Access Compliance Report Public Rights-of-Way (Curb Ramps)

Main Street: WINSLOW_ST Cross Street: ARTISAN_ST Location: N

ADA ID: RPRK211020164353 Ramp Type: Type 4 - Parallel Initial Pass/Fail: Fail Overall Compliance: No Severity Score: 2

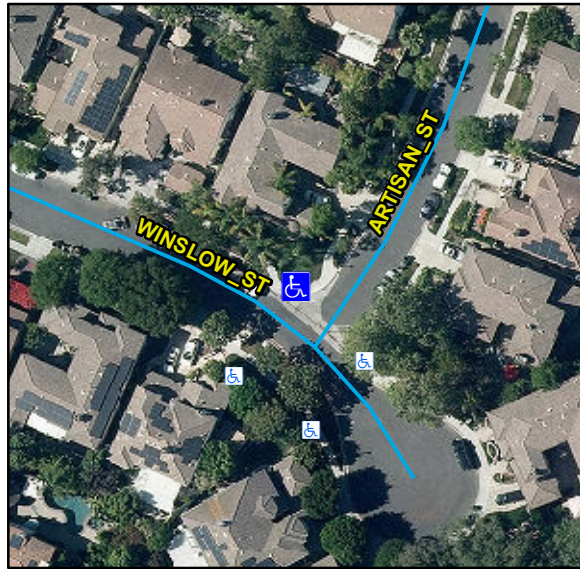
Compliance	Description	Data	Compliance	Description	Data
N/A	Ramp Length LT (in)	119	N/A	Ramp Length RT (in)	114
Yes	Ramp Width LT (in)	53	Yes	Ramp Width RT (in)	52
Yes	Ramp Run Slope LT (%)	6.6	Yes	Ramp Run Slope RT (%)	5.6
No	Ramp Cross Slope LT (%)	2.9	No	Ramp Cross Slope RT (%)	2.2
N/A	Landing Present	N/A	N/A	DWS Provided	N/A
N/A	Landing Length (in)	N/A	N/A	DWS Contrast	N/A
N/A	Landing Width (in)	N/A	N/A	DWS Length (in)	N/A
N/A	Landing Run Slope (%)	N/A	N/A	DWS Full Width	N/A
N/A	Landing Cross Slope (%)	N/A		DWS Offset Type	N/A
N/A	Landing Movement Obstructed?	N/A	N/A	DWS Offset Left (in)	N/A
	Landing Movement Type	N/A	N/A	DWS Offset Right (in)	N/A
N/A	Landing Shared	N/A			
N/A	Clear Space	Yes			
N/A	Clear Space To Crosswalk (in)	N/A			
N/A	Marked Crosswalk 1	No	N/A	Marked Crosswalk 2	No
	Crossing 1 Direction	SW		Crossing 2 Direction	SE
	Marked Crosswalk 1 Width (in)	N/A		Marked Crosswalk 2 Width (in)	N/A

Remove & Replace Curb Ramp With Two New Directional Ramps or Equivalent.
